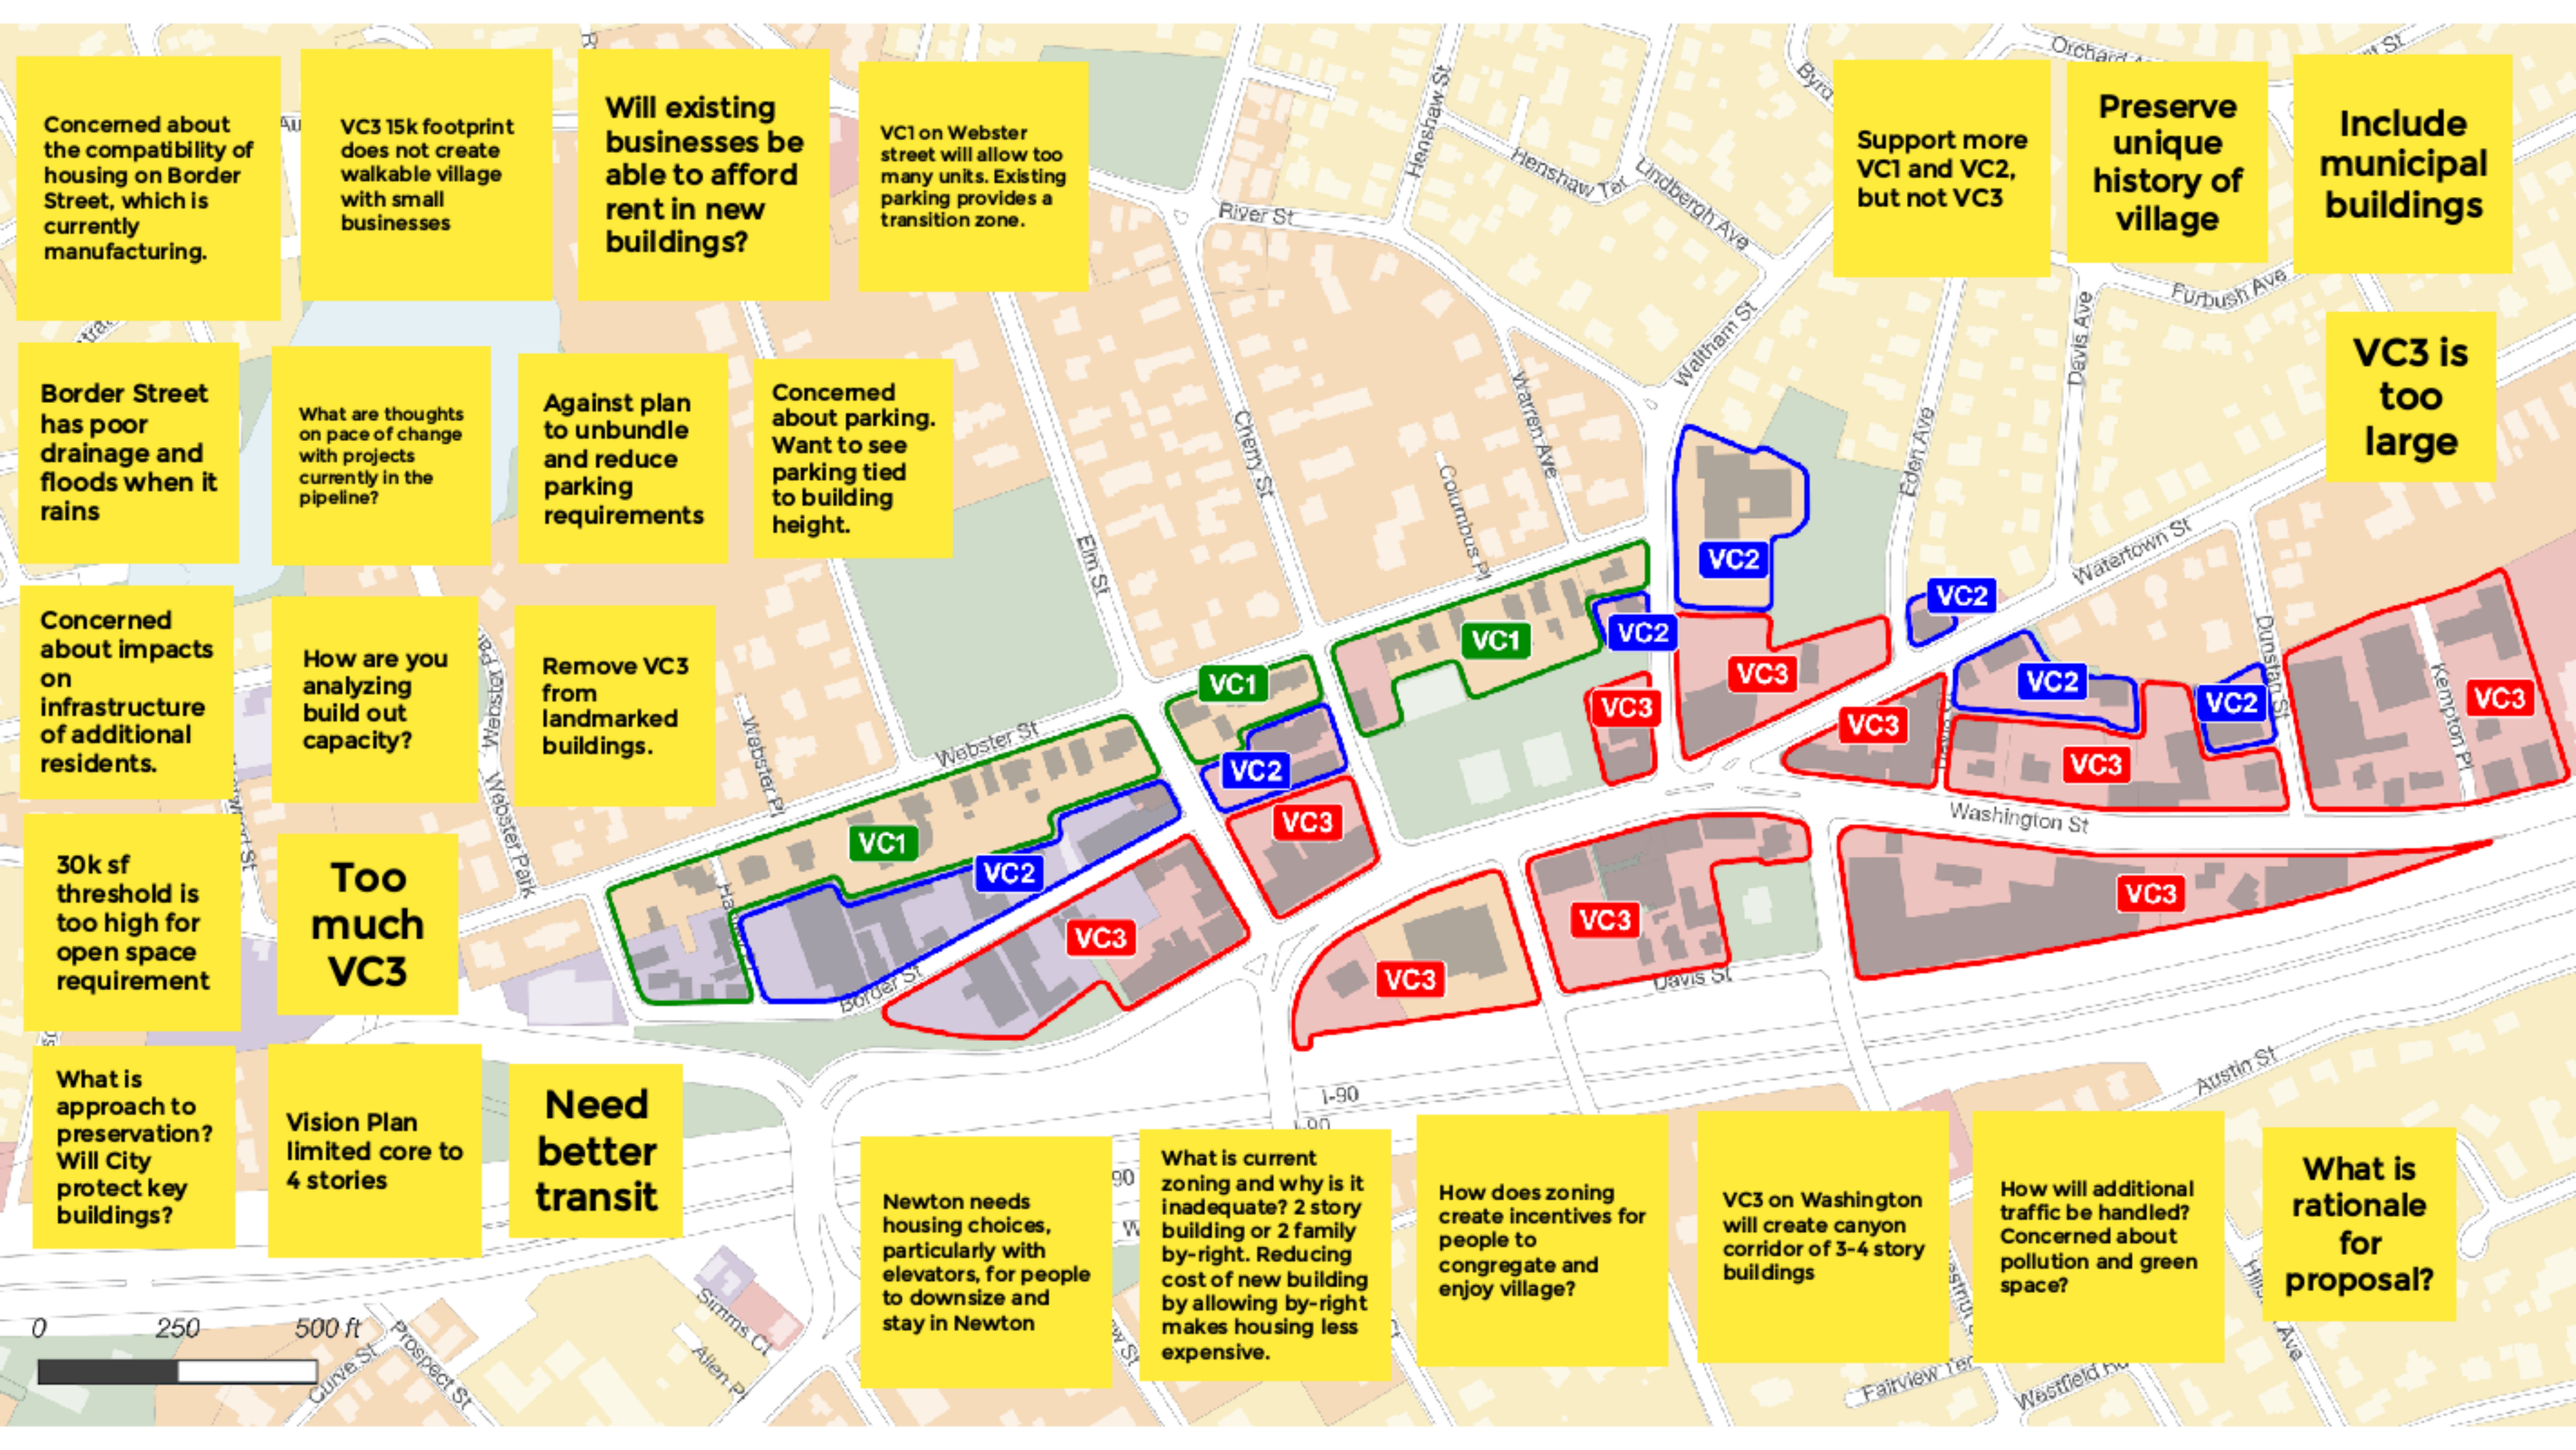
Concerned about the compatibility of housing on Border Street, which is currently manufacturing.

VC3 15k footprint does not create walkable village with small businesses

Will existing businesses be able to afford rent in new buildings?

VC1 on Webster street will allow too many units. Existing parking provides a transition zone.

Support more VC1 and VC2, but not VC3

Preserve unique history of village

Include municipal buildings

Border Street has poor drainage and floods when it rains

What are thoughts on pace of change with projects currently in the pipeline?

Against plan to unbundle and reduce parking requirements

Concerned about parking. Want to see parking tied to building height.

VC3 is too large

Concerned about impacts on infrastructure of additional residents.

How are you analyzing build out capacity?

Remove VC3 from landmarked buildings.

30k sf threshold is too high for open space requirement

Too much VC3

What is approach to preservation? Will City protect key buildings?

Vision Plan limited core to 4 stories

Need better transit

Newton needs housing choices, particularly with elevators, for people to downsize and stay in Newton

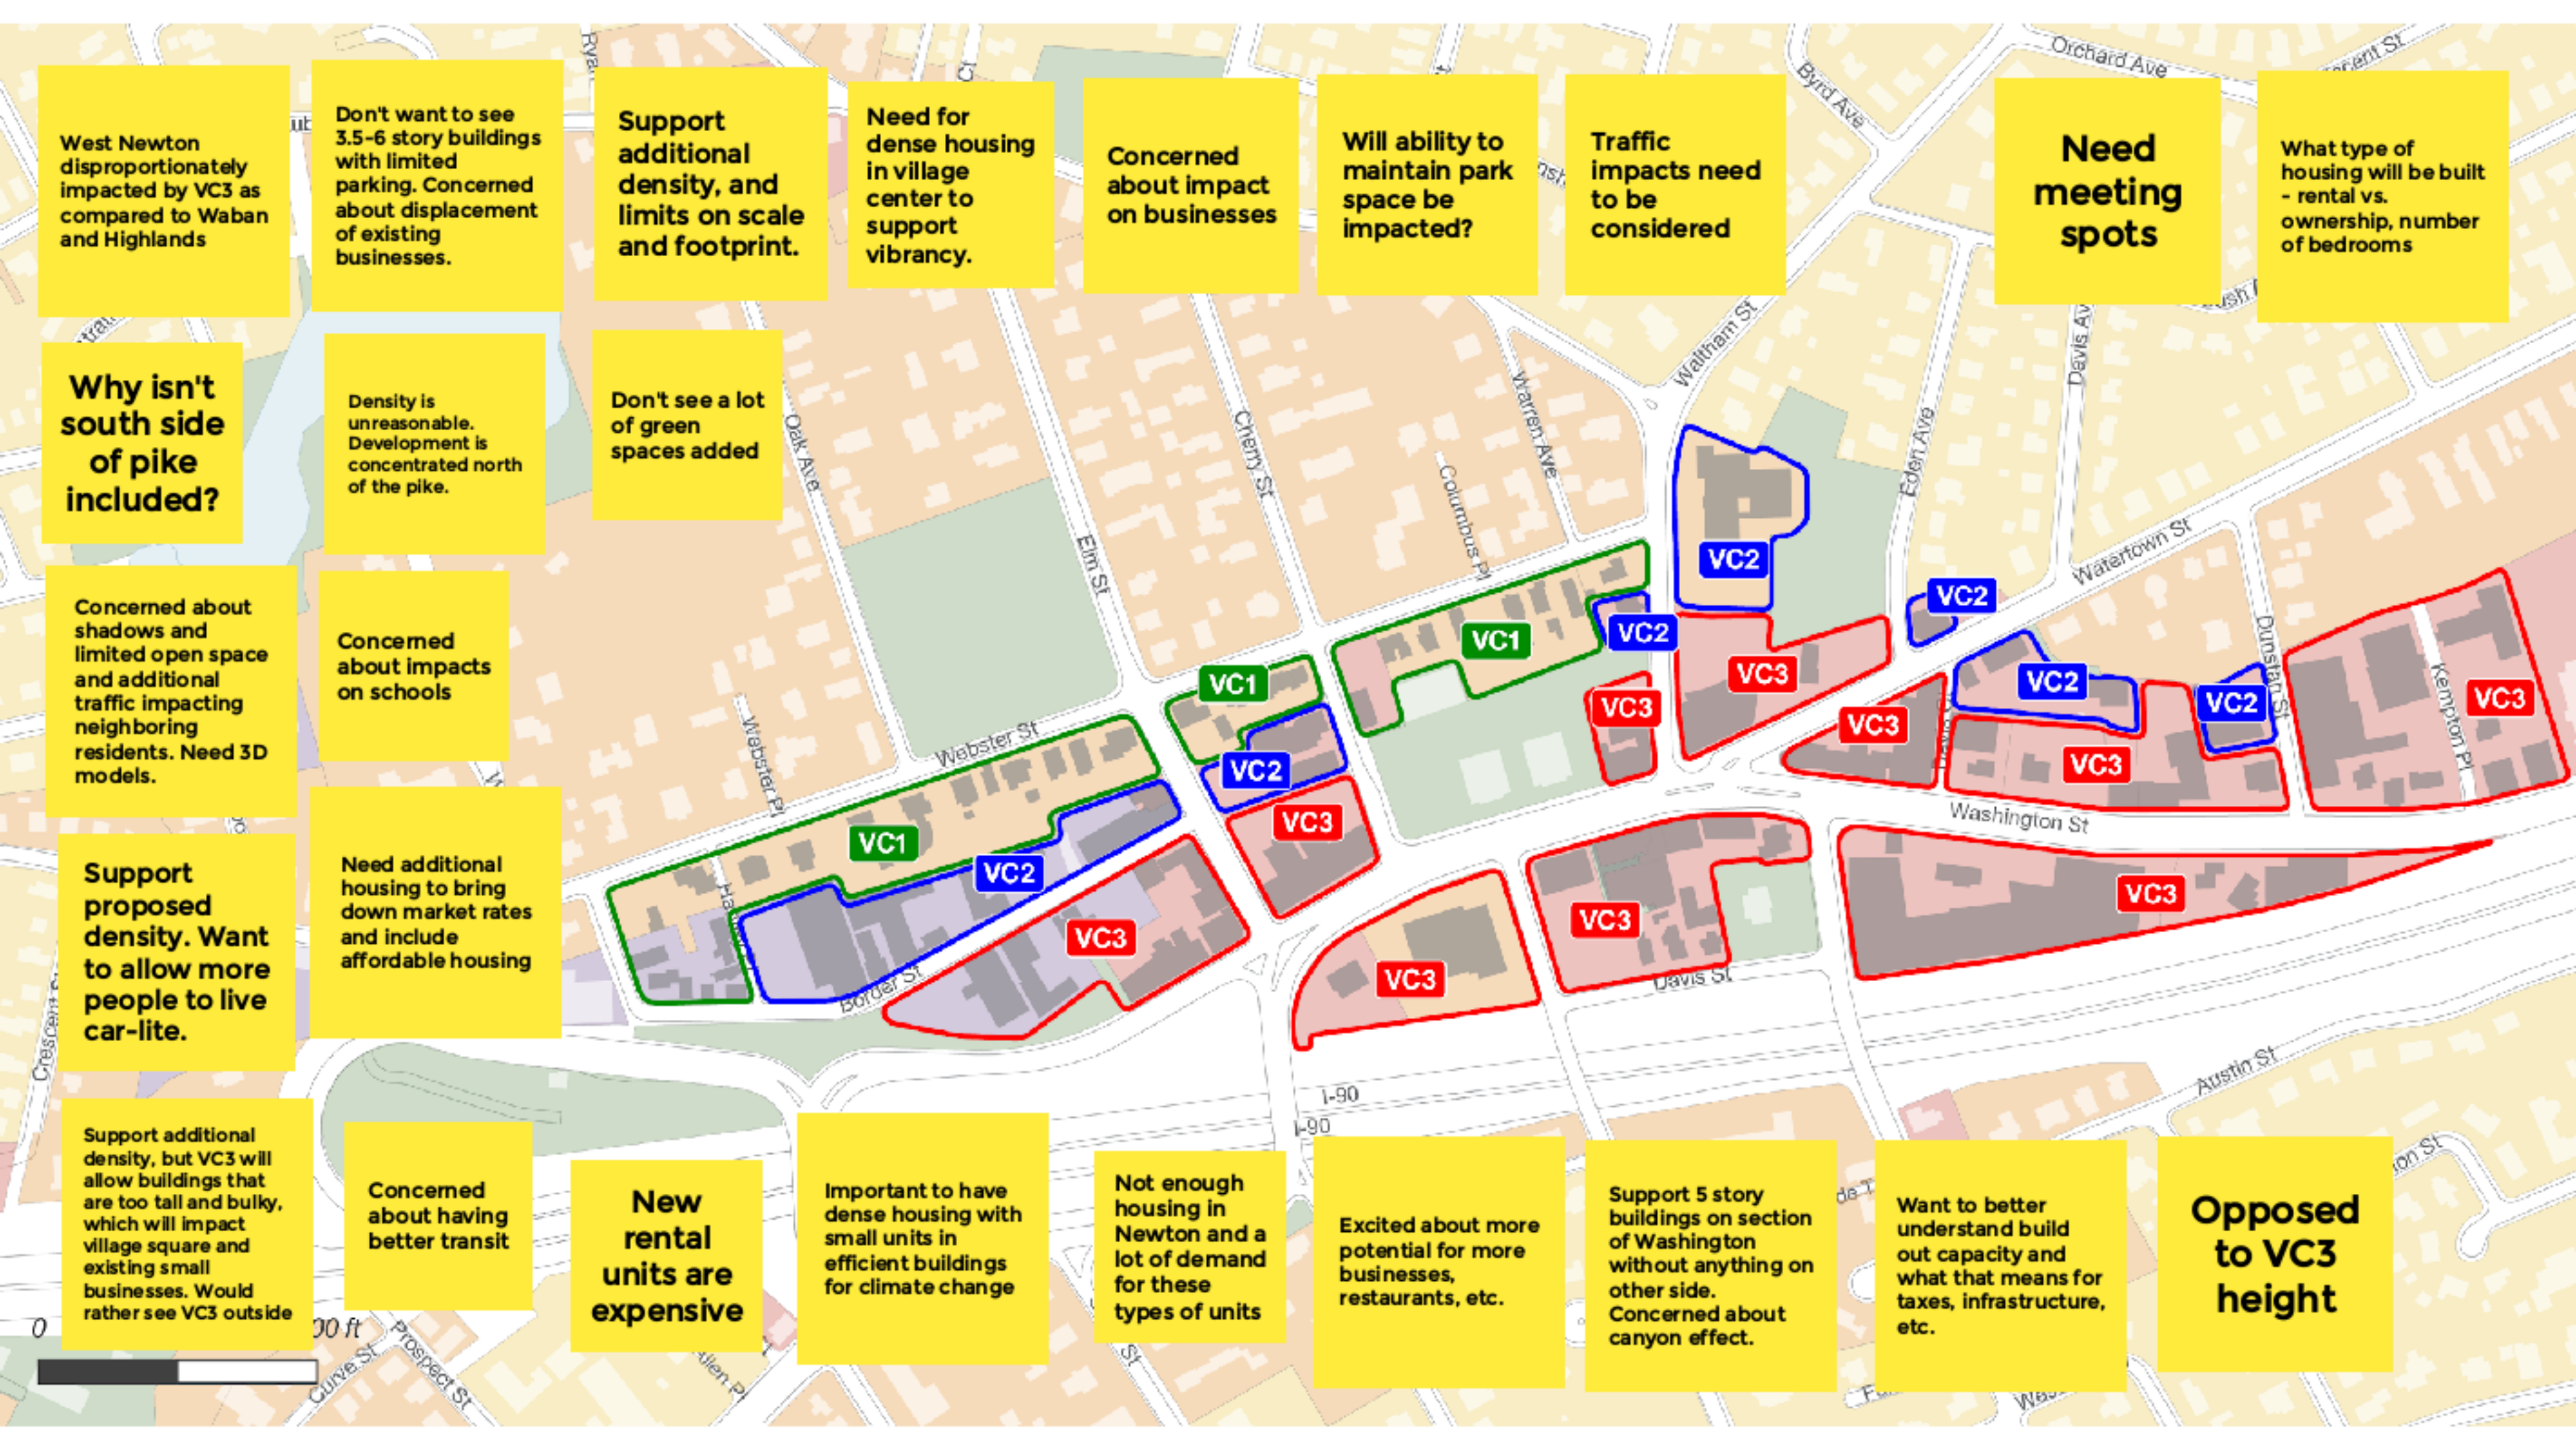
What is current zoning and why is it inadequate? 2 story building or 2 family by-right. Reducing cost of new building by allowing by-right makes housing less expensive.

How does zoning create incentives for people to congregate and enjoy village?

VC3 on Washington will create canyon corridor of 3-4 story buildings

How will additional traffic be handled? Concerned about pollution and green space?

What is rationale for proposal?

West Newton disproportionately impacted by VC3 as compared to Waban and Highlands

Don't want to see 3.5-6 story buildings with limited parking. Concerned about displacement of existing businesses.

Support additional density, and limits on scale and footprint.

Need for dense housing in village center to support vibrancy.

Concerned about impact on businesses

Will ability to maintain park space be impacted?

Traffic impacts need to be considered

Need meeting spots

What type of housing will be built - rental vs. ownership, number of bedrooms

Why isn't south side of pike included?

Density is unreasonable. Development is concentrated north of the pike.

Don't see a lot of green spaces added

Concerned about shadows and limited open space and additional traffic impacting neighboring residents. Need 3D models.

Concerned about impacts on schools

Support proposed density. Want to allow more people to live car-lite.

Need additional housing to bring down market rates and include affordable housing

Support additional density, but VC3 will allow buildings that are too tall and bulky, which will impact village square and existing small businesses. Would rather see VC3 outside

Concerned about having better transit

New rental units are expensive

Important to have dense housing with small units in efficient buildings for climate change
